Product Change Notification

Date Issued :	March 28, 2022	PCN Number :	511814
Reason for Change :	Packaging Method/Quantity Changing		
Description of Change :	This notification is to inform you about part(s) listed in this notice that will undergo changes for new Delivery unit. No changes will be made to the product as a result of this change.		
Reason for Short Notice :	Corrective Actions		
Assessment of Change :	Dimension analysis		
Planned Implementation Date :	June 03, 2022		
Sample Availability Date:	March 31, 2022		
Internal Molex Qualification Date :	May 13, 2022		
Last date to request Samples by Customer :	March 31, 2022

Before Picture

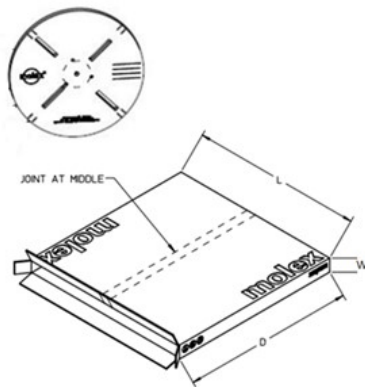
Before:

Single Reel (20,000pcs) in a
1.5" Tall Box.

After Picture

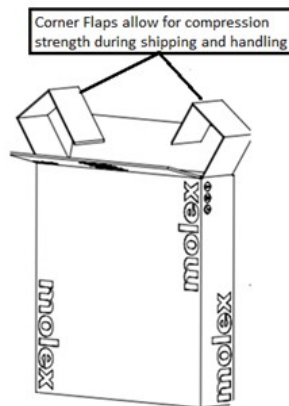
After:

4 Reels (80,000pcs) in a
5" Tall Box.
